**PLANNING AND ZONING COMMISSION MEETING**  
**Tuesday, January 27, 2015**  
**6:00 P.M.**  
**COUNCIL CHAMBERS**  
**CITY HALL, 200 NORTH DAVID STREET**

- B. **PLN-14-068-S – (Continued from November 25, 2014) Planned Unit Development (PUD) site plan amendments to the Greenway Park PUD (also known as “The Preserve”); and detailed site plan approval for Phase III, “The Enclave at Greenway Park,” Said amendment to the PUD propose to increase the allowable site density from a maximum of 429 dwelling units to a maximum of 530 dwelling units, and is reconfiguring the overall site and street layout. The Greenway Park PUD is generally located north of East 21st Street and east of South Missouri Avenue. Applicant: Haystack Properties, LLC.**

SUBJECT: **PLN-14-068-S** – *(Continued from November 25, 2014)* Planned Unit Development (PUD) site plan amendments to the Greenway Park PUD (also known as “The Preserve”); and detailed site plan approval for Phase III, “The Enclave at Greenway Park,” Said amendment to the PUD proposes to increase the allowable site density from a maximum of 429 dwelling units to a maximum of 530 dwelling units, and is reconfiguring the overall site and street layo

# GREENWAY PARK | OVERALL SITE DEVELOPMENT PLAN

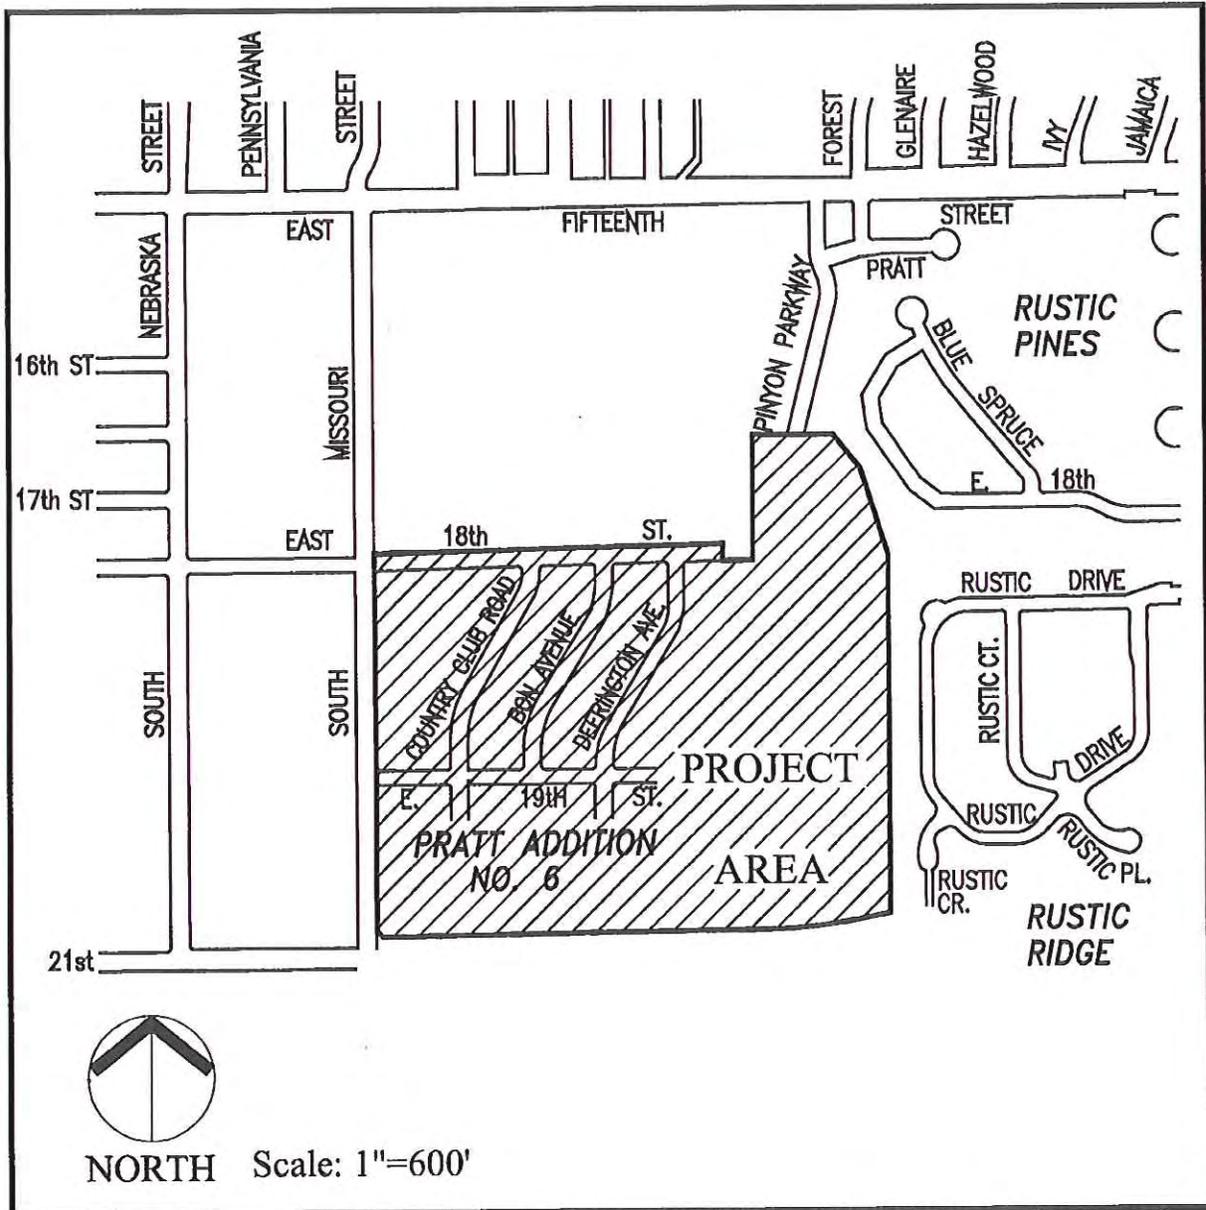
4. There is a discrepancy between the narrative outlining changes to Section VI(D) of the PUD Guidelines pertaining to allowing parking on both sides of public streets, and the street cross sections provided on Exhibit A (Overall Site Development Plan), which shows that public streets are designed for parking on only one side of the street. Prior to final approval of the PUD amendments, the discrepancy shall be corrected.
5. Upon final approval of amendments to the original PUD (Planned Unit Development) Guidelines, the applicant shall provide, to the Community Development office, a complete set of new PUD Guidelines, both in hard copy and digital format, which shall supersede and replace the previously approved Guidelines.
